Re: Reevaluation Report
Horse Valley Road Horizontal Directional Drill Locations (S2-0157)
Permit No. E50-258
Toboyne Township, Perry County

**HORIZONTAL DIRECTIONAL DRILL ANALYSIS
HORSE VALLEY ROAD CROSSING
PADEP SECTION 105 PERMIT NO. E50-258
PA-PE-0002.0000-RD & PA-PE-0002.0000-RD-16
(SPLP HDD No. S2-0157)**

Figure 3. Original 16-Inch HDD Plan and Profile

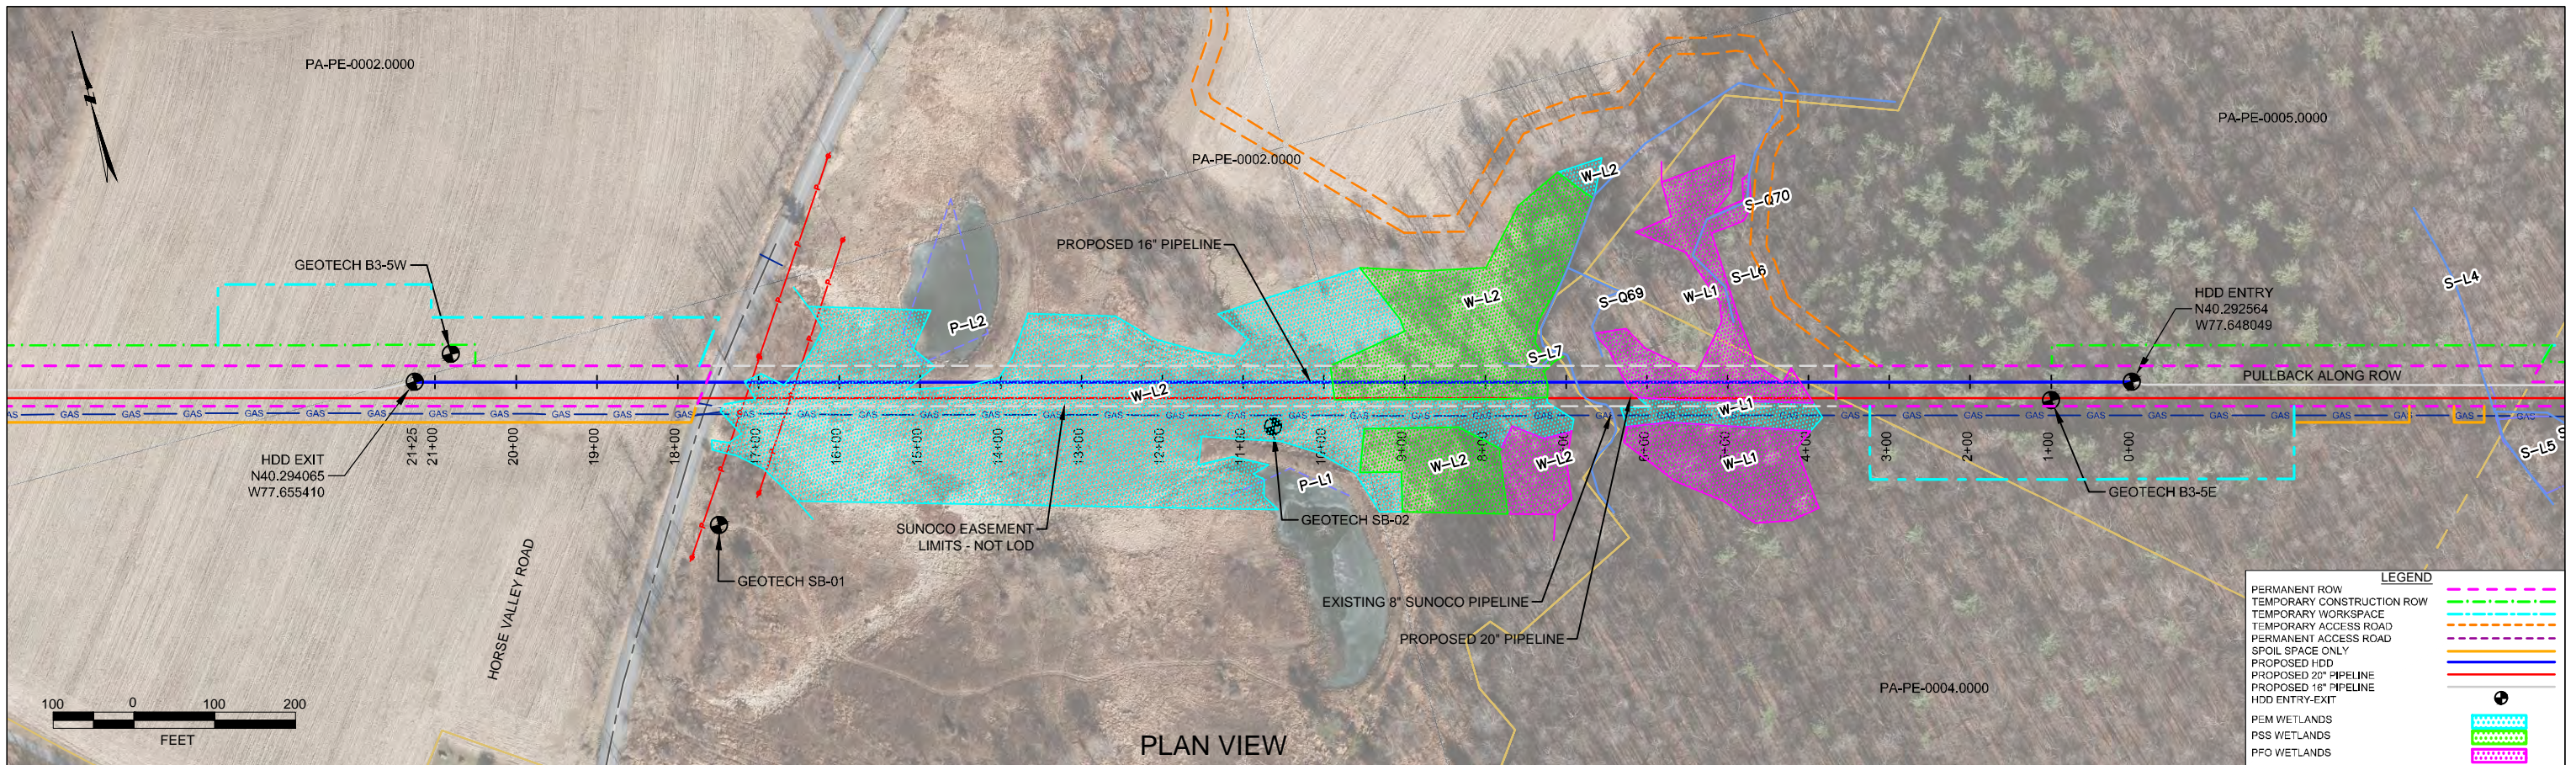
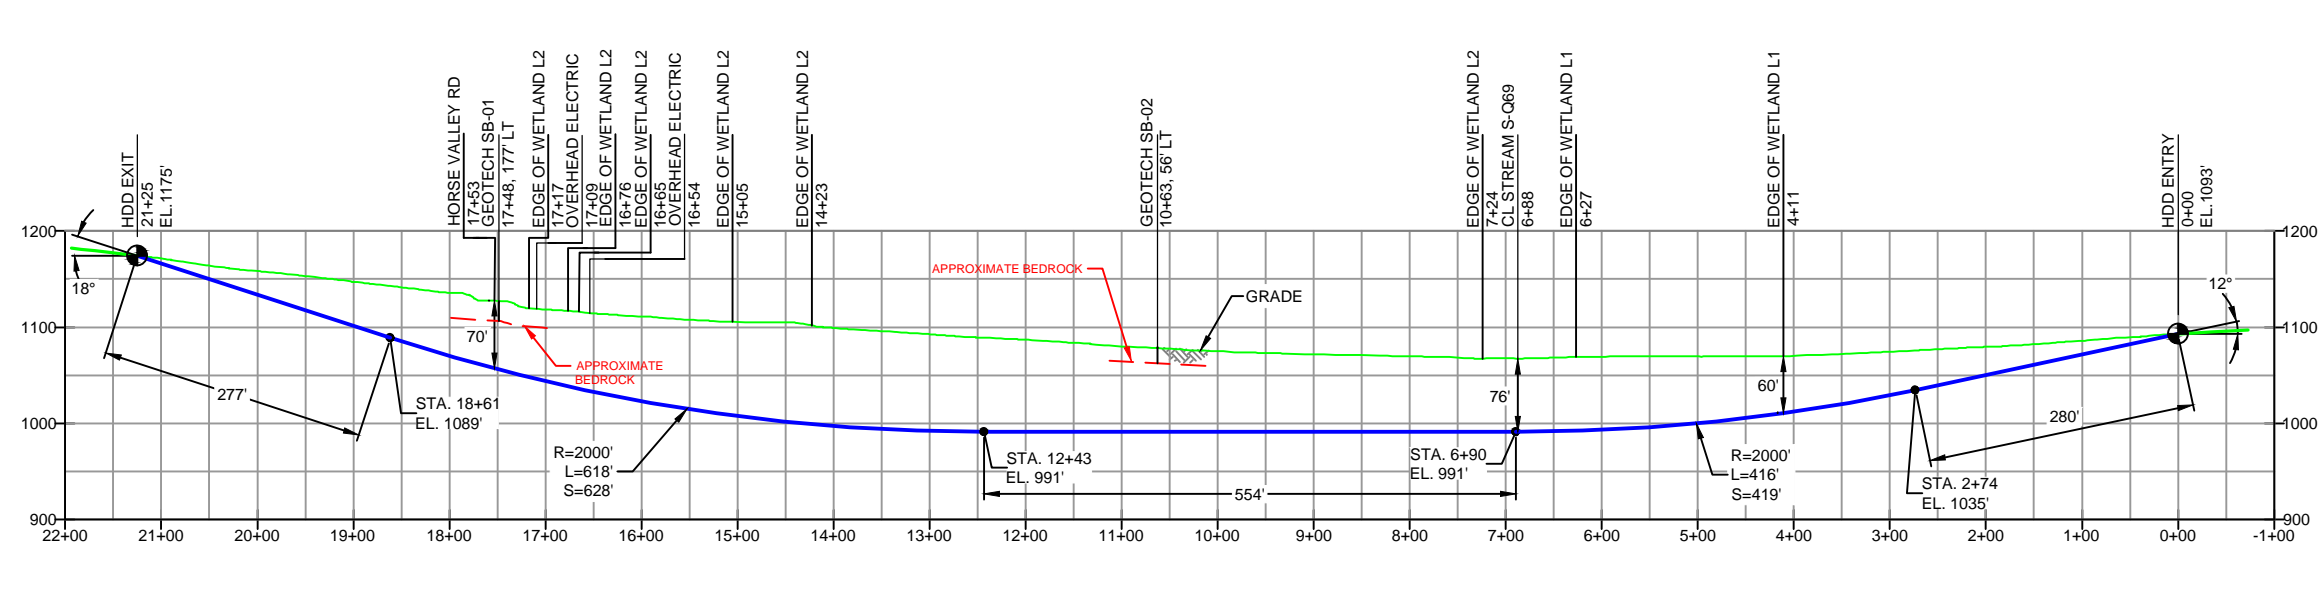
It is SPLP's intent to modify the original profile design and to pursue a deeper and longer HDD profile. Figure 1 and 3 in Attachment 4 presents the original HDD plan and profiles. Figure 2 and 4 in Attachment 4 present the revised HDD plan and profiles.
